# Department of Planning and Infrastructure

# Independent Transport Review

Issue | 22 November 2012

Figure 2 Recommended Infrastructure Works

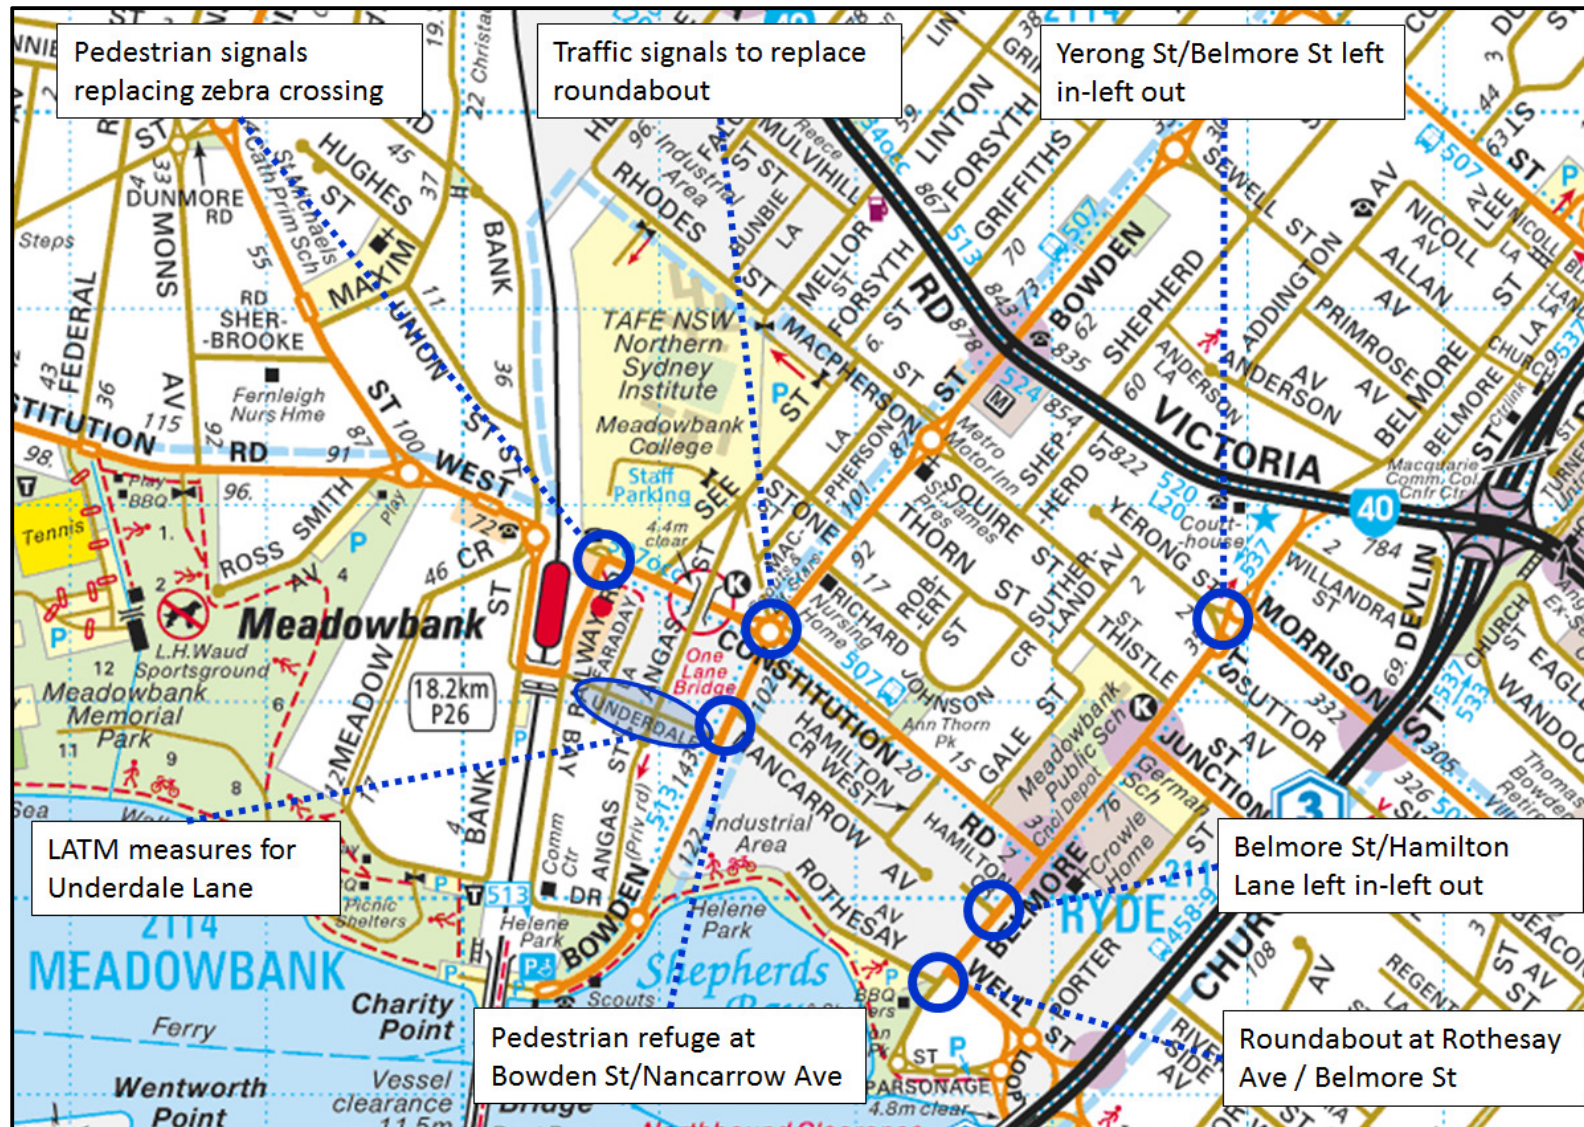
A summary of these recommended works, as well as suggested staging advice, is outlined in Figure 2 and Table 7.
